**SUBJECT: Project No. R2014-02411-(5)
Minor Conditional Use Permit No. 201400014, Oak Tree Permit No.
201400035, and Environmental Assessment No. 201400194
HO Meeting: April 19, 2016
Agenda Item: 5**

Re: Oak Tree Permit No. 201400035, APN: 5830-003-016 - Canyon Crest Road
LDC Project No. 13038-001

At the request of Mr. Alex Garcia, Hearing Officer for this project, Land Design Consultants, Inc. (LDC) has reviewed the Independent Arborist Review of the Oak Tree Report, prepared by Rebecca Latta Arboricultural Consulting, dated March 17, 2016. Please be aware that LDC's involvement in the project in 2014 was at an early stage of the project submittal process. LDC's report was submitted to the applicant, Mr. Stephen Kuhn, in August 2014 and we have not been in contact with him or any County representative since that time. We were contacted and first made aware of Ms. Latta's review by the applicant only a few weeks ago when Ms. Latta submitted her comments, and we are responding at our earliest convenience.

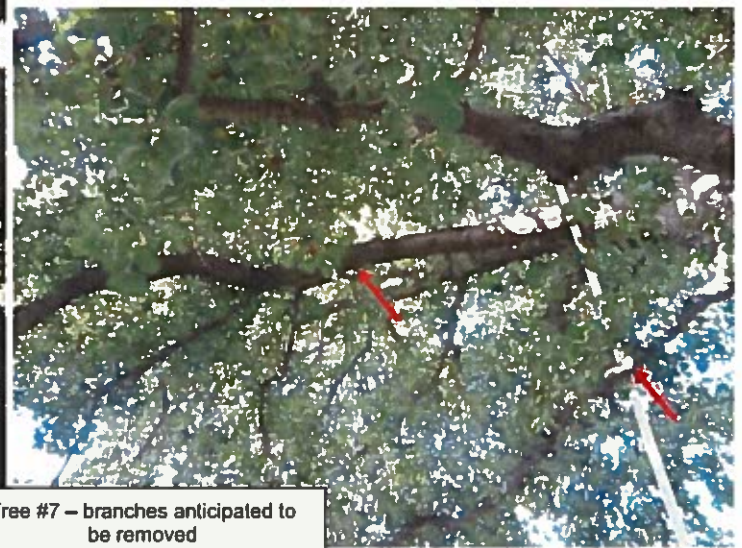
- e. The percentage of root zone and canopy impacts are not mentioned. The arborist specifies a distance to impacts, but does not discuss the relevance of the impact to tree health. Only that they might occur. How does the arborist determine whether the impacts are great enough to recommend removal of the protected trees?

Response – Of the trees that are proposed for encroachments, trees #4 and 7 will have the greatest impacts by the project design. These impacts are greater than those previously indicated in the August 2014 report. As stated in that report, the placement of the below grade wall will take place approximately four feet (to the west) of the trunk of tree #4. Based on the Site Plan, dated March 4, 2016, it is estimated that approximately 25% of the root system will be impacted by the excavation required for the placement of the wall. Since the location of actual roots is unknown until excavation occurs, actual impacts to specific roots cannot be determined at this time. Excavation should be performed under the Arborist of Record's guidance.

As stated in the August 2014 report, the placement of the below grade wall will take place approximately six feet (to the south) of the trunk of tree #7. Based on the Site Plan, dated March 4, 2016, it is estimated that approximately 27% of the root system will be impacted by the excavation required for the placement of the wall. Since the location of actual roots is

unknown until excavation occurs, actual impacts to specific roots cannot be determined at this time. Excavation should be performed under the Arborist of guidance.
